| Title - Sujet Exterior Lighting Additions | |
| Solicitation No. - N° de l'invitation EZ899-161037/B | Amendment No. - N° modif. 003 |
| Destination - of Goods, Services, and Construction: Destination - des biens, services et construction: Parks Canada - Fort Rodd Hill National Historic Site - Victoria, BC | |

Please find Amendment #3 herein.

ESK1-E10.1

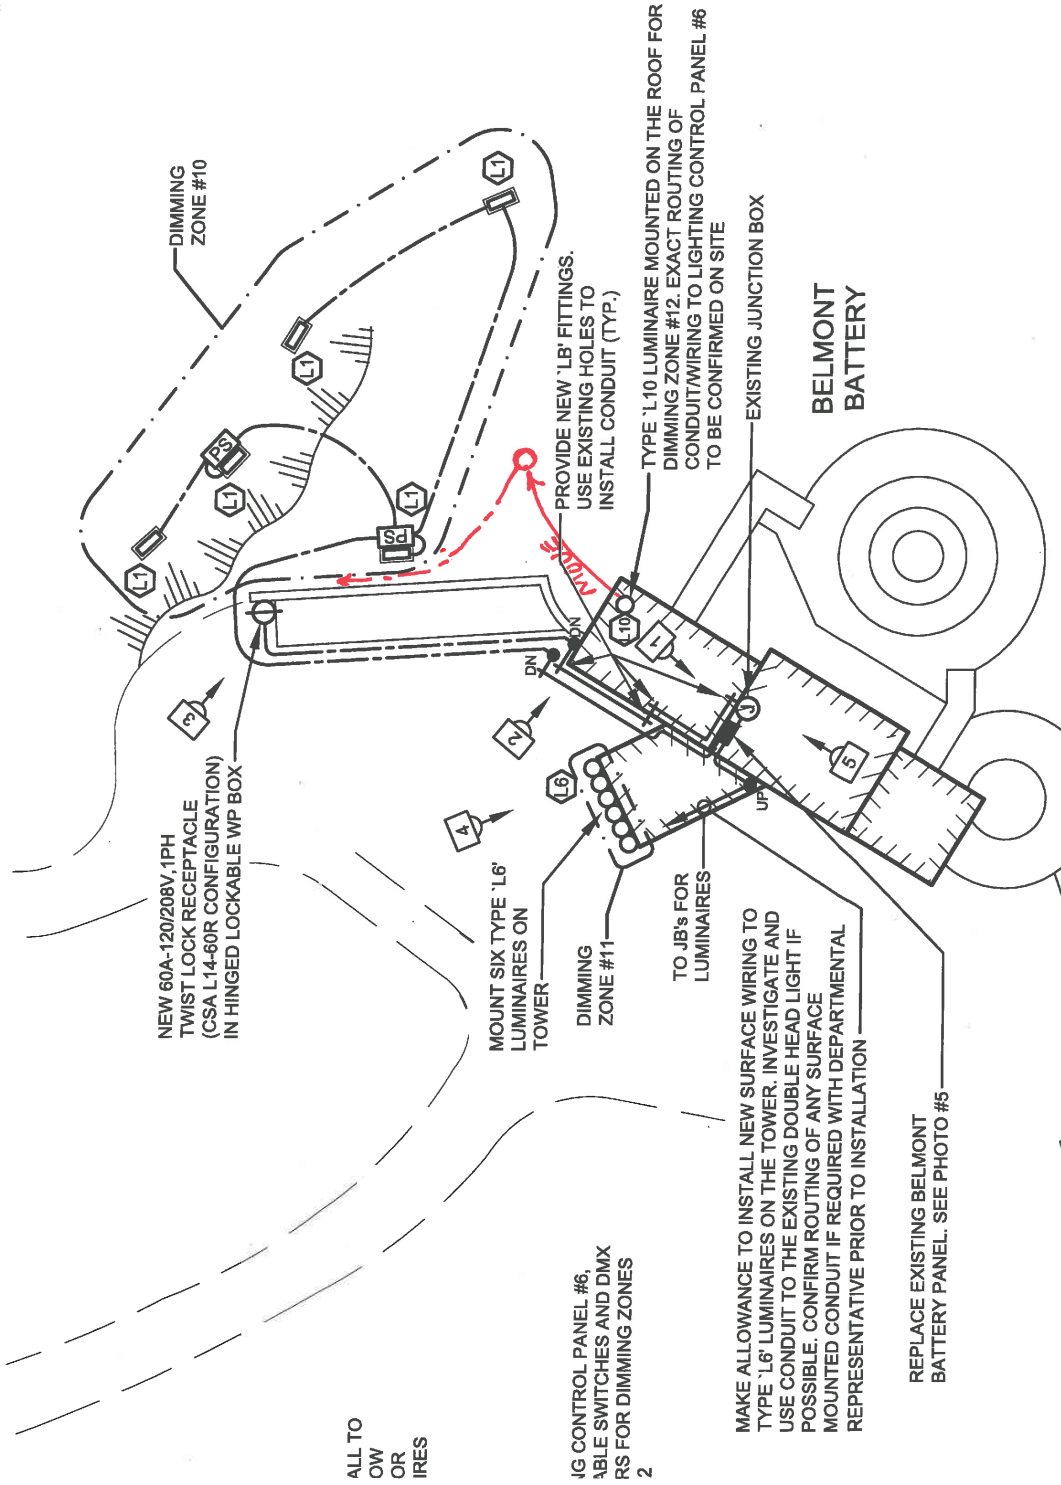
- (2) **Revise** : location of type ‘L10’ luminaire currently indicated to be installed on the roof of Belmont Battery Bldg. Install at the edge of the “rough” on east side of Belmont Battery glacis using a 4’ high, hot dipped galvanized steel HSS post c/w mounting brackets as noted in Luminaire Schedule on Dwg. E200. Exact routing of u/g conduit to lighting control panel #6 to be confirmed on site.

ESK1-E102

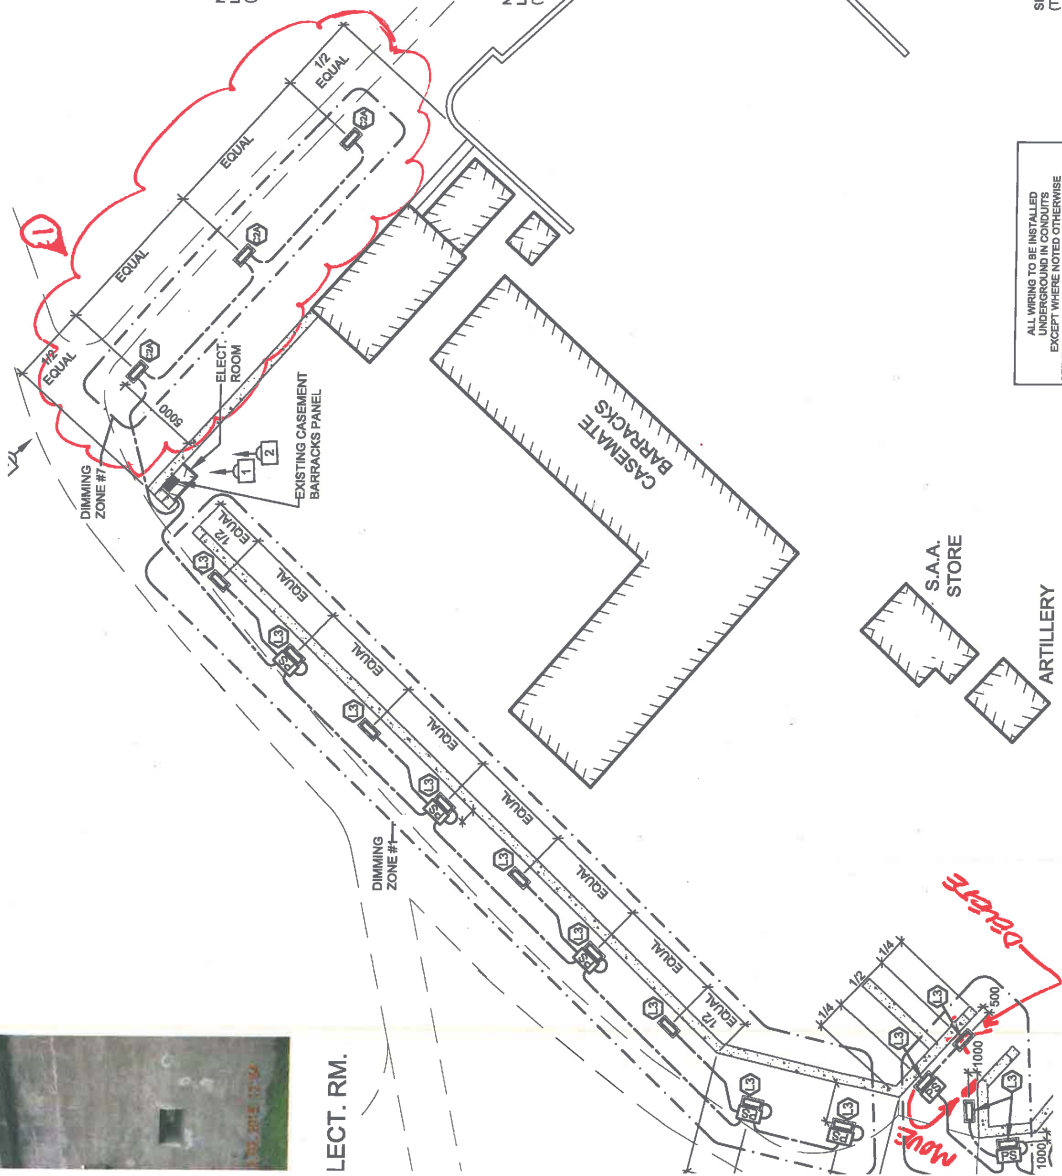
- (3) **Add** : keynote #1 to read:
“Very archaeologically sensitive area. Refer also to Appendix ‘B’ in the specifications. No machine digging; only hand digging is allowed in this area. Review the results of archaeological testing and pre-construction coring with Departmental Representative prior to any trenching. Distance of luminaires from the wall may need to be reduced to 2m depending on the results of testing.”

- (4) **Move** : one type ‘L3’ luminaire as noted in ESK1-E102 at entrance to Lower Battery area.
- (5) **Delete**: one type ‘L3’ luminaire as noted in ESK1-E102 at entrance to Lower Battery Area.

- (6) **Revise**: note for photo #6 to read:
“Remove the wooden cabinet enclosing the exiting panelboard and receptacle. Replace the existing panelboard with a new 8-cct. Stab-lok load centre c/w sufficient circuit breakers to re-feed existing circuits and new lighting circuit. Provide a new lockable stainless steel cabinet to enclose the new load centre,
-

- (7) **Revise:** routing of conduits from Casement Barracks electrical room to type ‘C2A’ and ‘L3’ luminaires. Refer also to photos #1 and #2. Instead of drilling into the historic fabric of red brick wall as shown in photo #1, route the conduits from the wall of the electrical room down into u/g and out of the electrical room using existing gap area in the concrete floor.
- (8) **Add :** to the note pointing to surface mount conduit in photo #5 to read:
“Avoid drilling into historic fabric of wooden post. Fabricate a non-invasive clamp to fit to the post and use to support the conduit. Paint to match the post.”

ESK1-E105

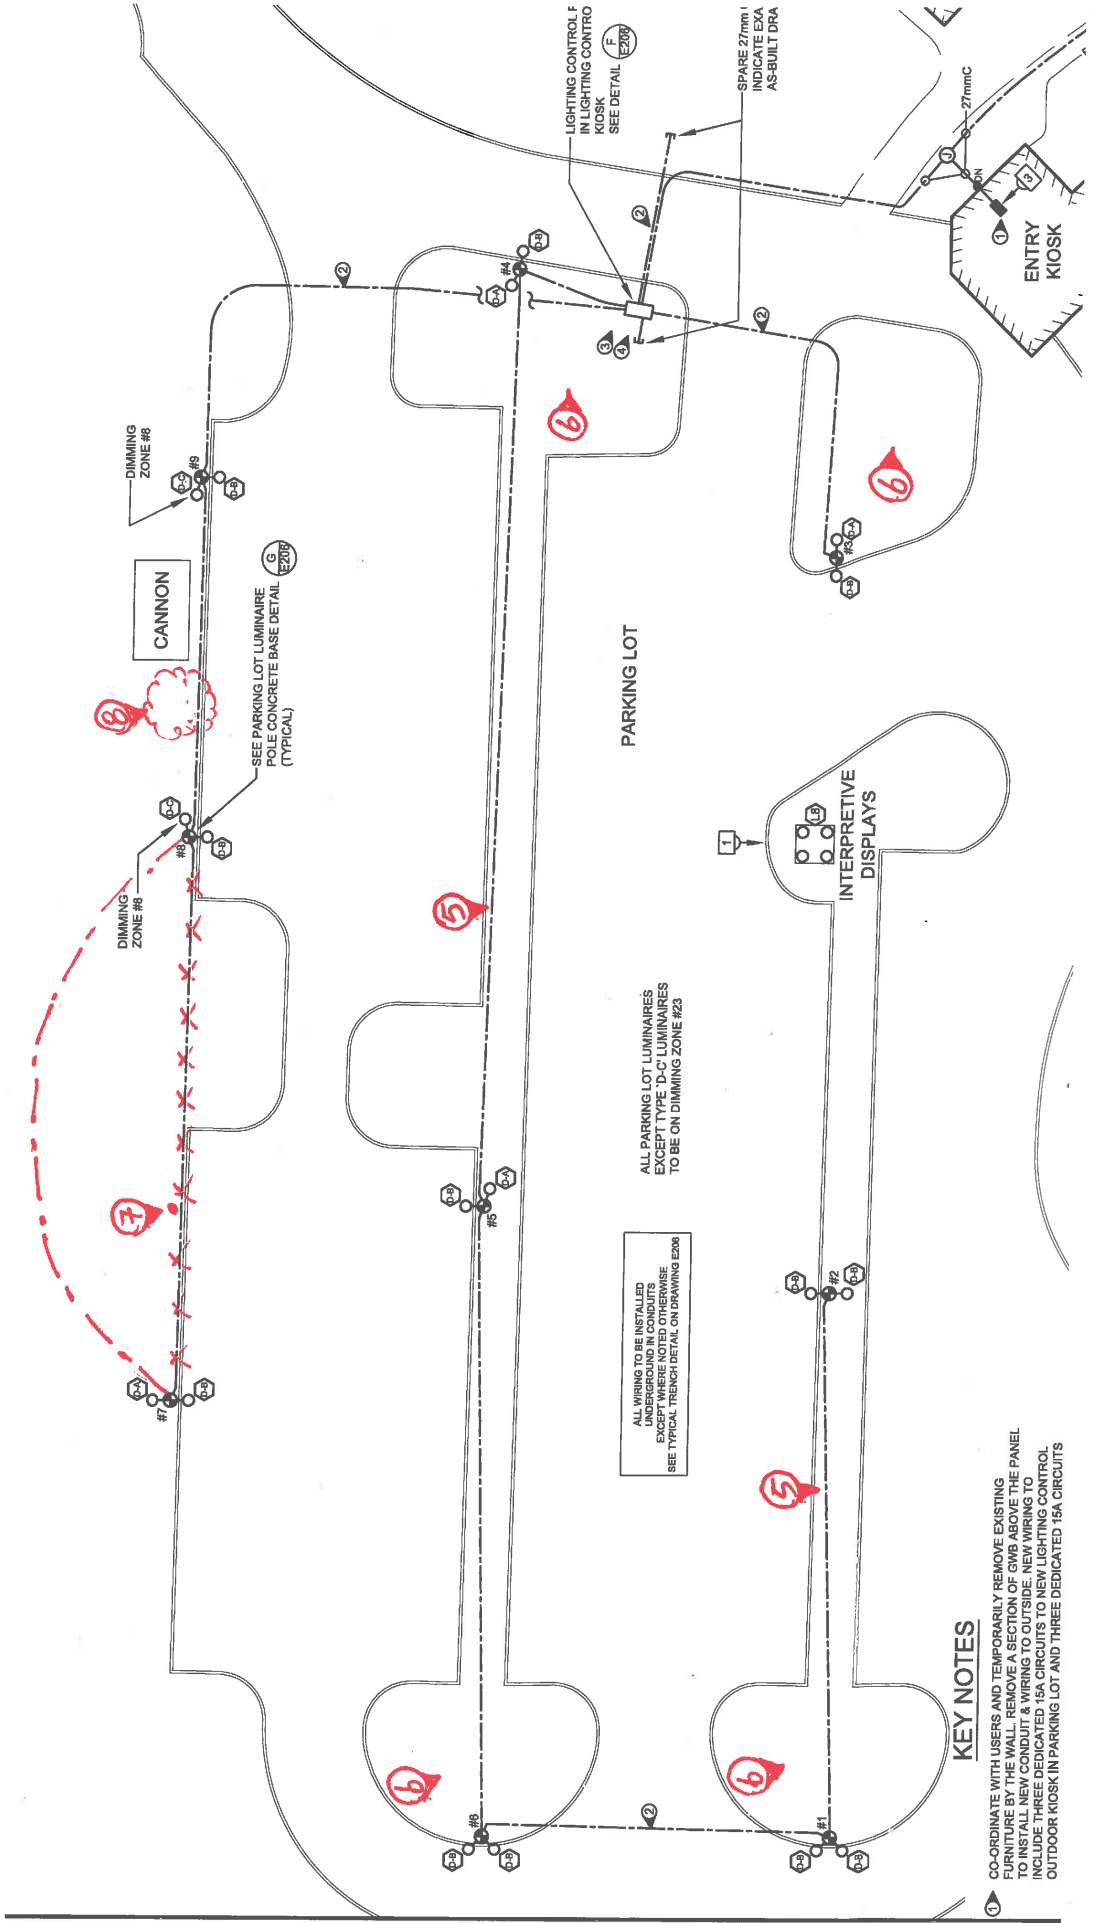
- (14) **Add :** keynote #5 to read:
“There are existing plants and an irrigation line in the centre of the island in the parking lot. Install new u/g conduits at one side of the island as close as possible to the curb to avoid plant roots and irrigation line.”
 - (15) **Add :** keynote #6 to read:
“Treed area and bushes. Coordinate with Departmental Representative re routing of u/g conduits in this area. Make allowance for conduit routings other than the
-

- (16) **Add** : keynote #7 to read:
“Existing BCH pole and cobra head luminaire. Contact BC Hydro for removal of existing cobra head luminaire. Make necessary allowances and pay to BC Hydro.”
- (17) **Revise** : routing of u/g conduit from pole #8 to pole #7 to avoid tree roots in the area.
- (18) **Add** : keynote #8 to read:
“There are existing water pipes and valves in this area. Protect existing services when installing u/g conduit.”

ESK1-E300

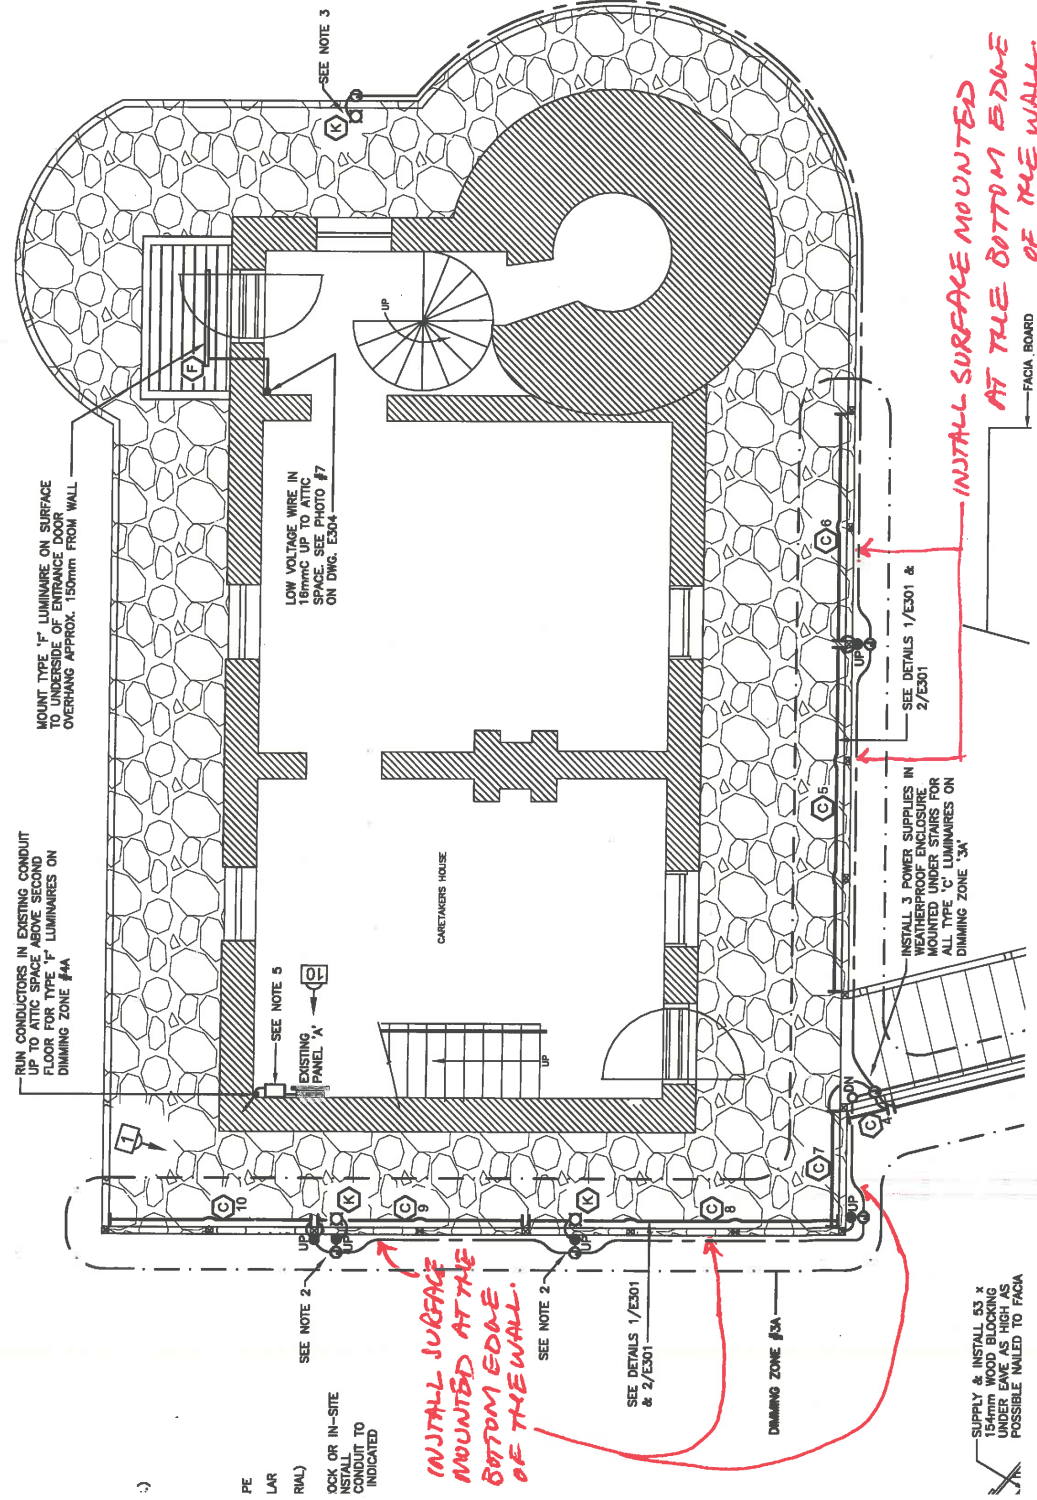
- (21) **Revise** : type of wiring installation around the Caretaker’s House from underground to surface mounted. All wiring installation to be done using liquid tight flexible conduit.

ESK1-E301

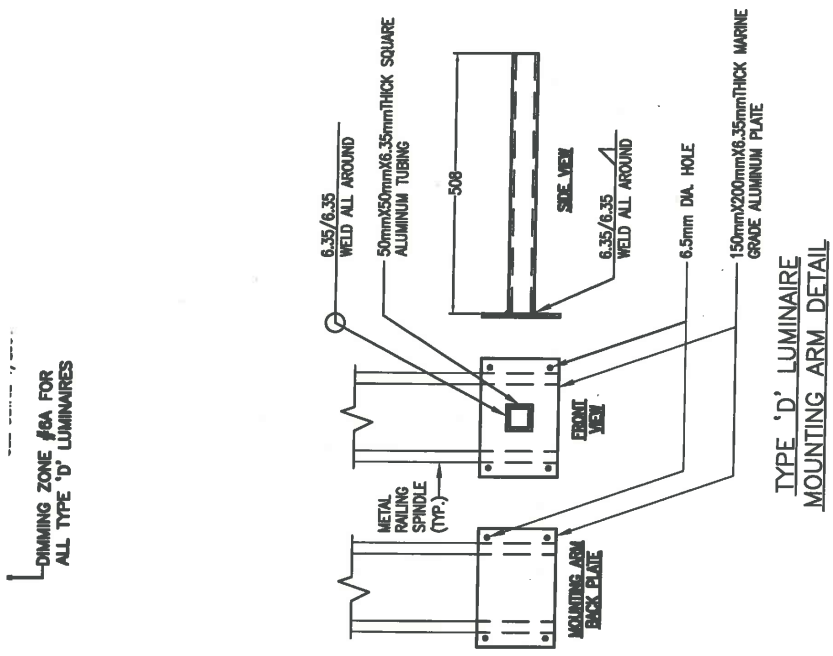
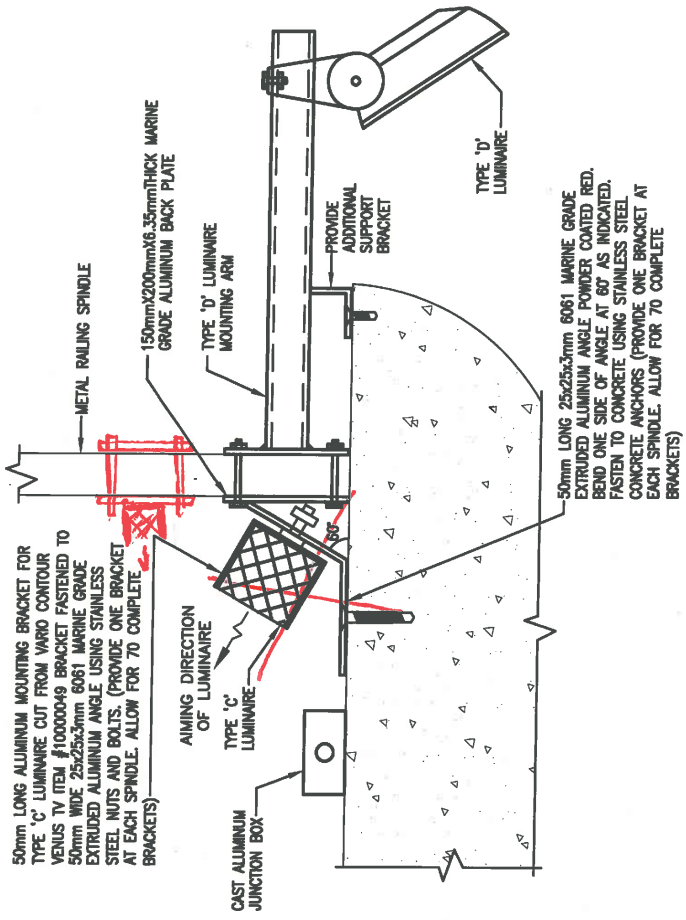
- (22) **Revise** : Revise type of bracket and mounting detail for type ‘C’ luminaire in detail 1. Instead of an angle bracket fixed to the concrete floor, use a flat bracket and fix onto the metal railing spindles the same way as bracket for type ‘D’ luminaires. All brackets to be powder coat painted red to match railings. In addition, color of mounting arm for type ‘D’ luminaires will be confirmed by Departmental Representative.

- (23) **Add** : the following note #11 for detail 4 to read:
“A standard portable power distribution unit such as those used in film industry will be acceptable in lieu of the unit shown in the detail if it meets the requirements as noted.”
-
